**U.S. EPR Design Certification Application - Closure of FSAR Group A Chapters 2, 13, 17 and AIA**

FINAL MARKUPS FOR GROUP A CHAPTERS FOR FSAR REVISION 6

# U.S. EPR Final Safety Analysis Report Markups For Chapter 2 Freeze

Figure 2.3-1—U.S. EPR Release Points, **and** Control Room Air Intakes, and Unfiltered Inleakage Locations

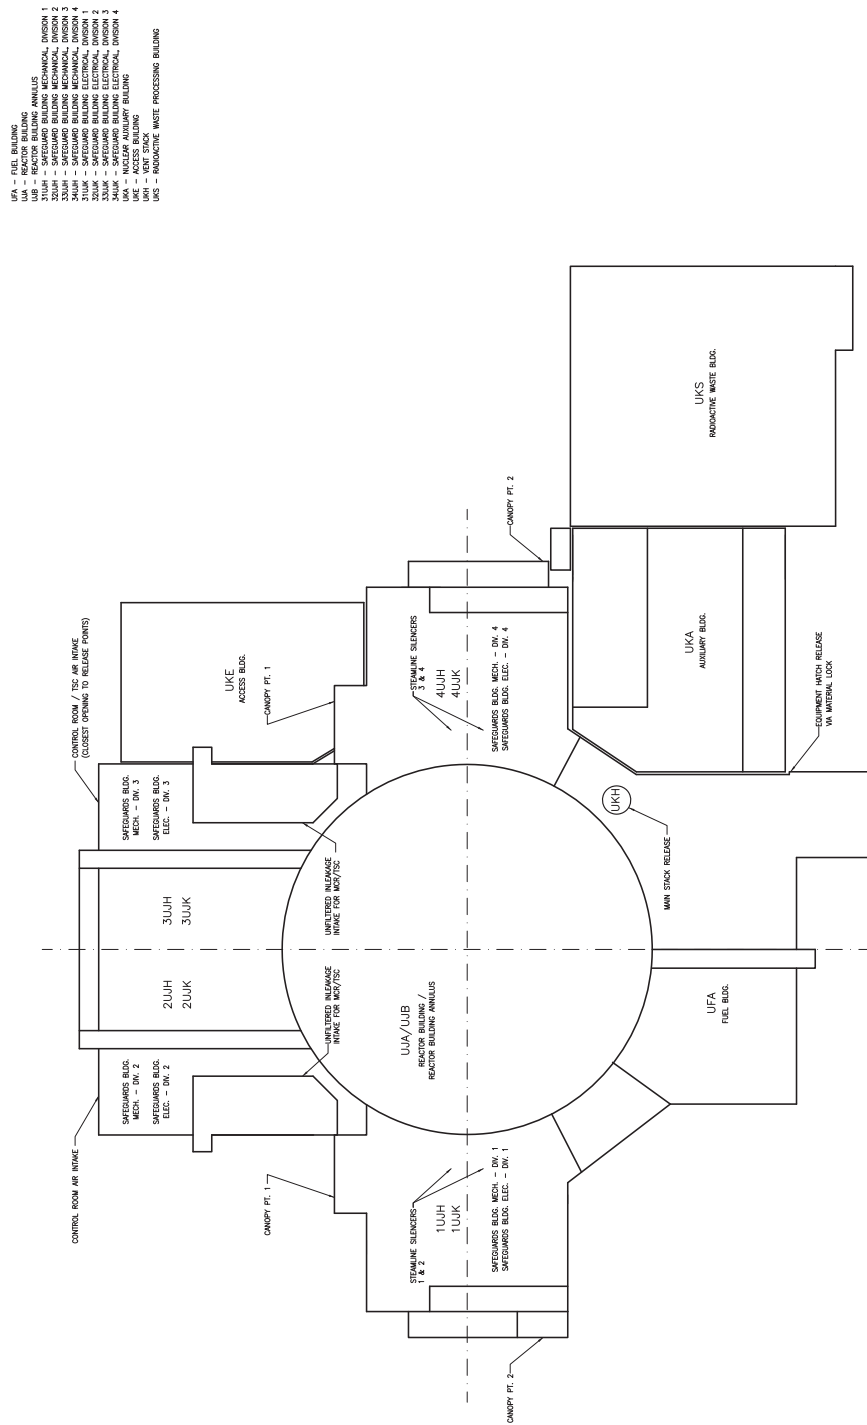
6. The atmospheric dispersion parameters for the equipment hatch ~~and depressurization shaft releases~~ are bounded by the parameters for the releases via the Safeguard Building canopy.
